U.S. Army Corps of Engineers New England District

Assabet River Sediment Management Plan

Attachment 4
**CDM Response to Mass DEP Comments on the Draft Sediment
Management Plan**

USACE Assabet River Sediment and Dam Removal Study
Sediment Management Plan
DEP Comments and CDM Responses
November 2008

Figure 2-4: Dredging Extents for Gleasondale Impoundment

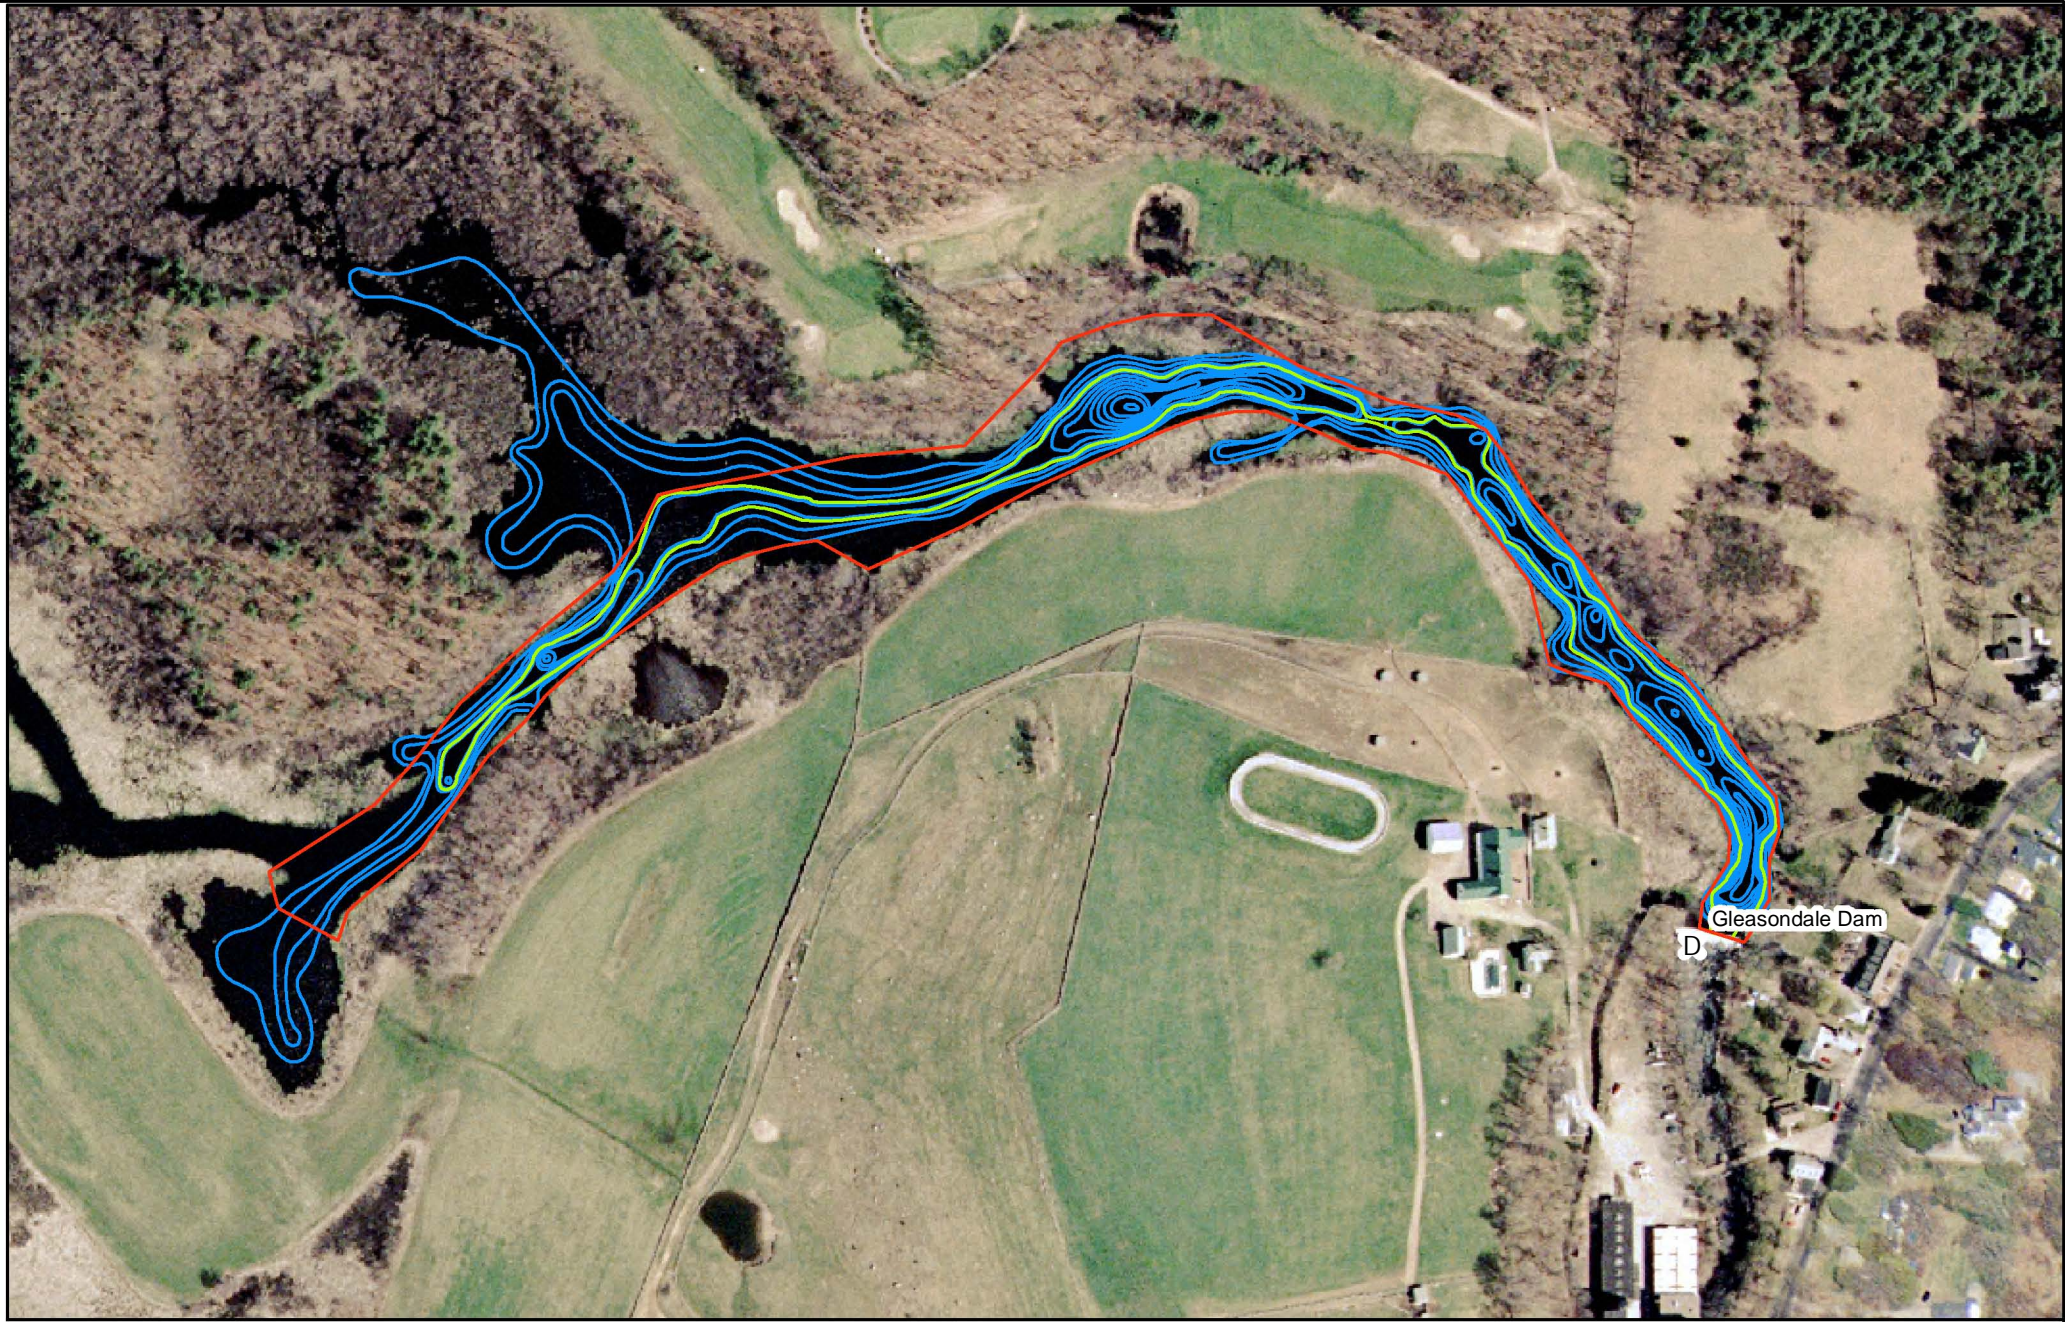
DEP Comment	CDM Response
<p>Figure 2.4 indicates a considerable upland/wetland area in Gleasondale Impoundment that may have to be dredged. The reasoning for dredging this particular area should be presented and clarification should be made that any dredging would have to go through normal permitting processes such as MEPA and the Wetland's Protection Act to achieve final approval.</p>	<p>The dredging boundaries as shown are approximate and were developed based on results of the HEC-6 modeling. Further studies are required during subsequent phases of this work to determine actual dredging boundaries.</p>
<p>It would be helpful if the summary USGS sediment data tables in Section 2 were flagged somehow to indicate when parameters were over the threshold limits.</p>	<p>The parameters that were above the threshold are highlighted in the revised plan. However, it should be noted that the testing of the dewatered and processed sediment may not show similar results.</p>
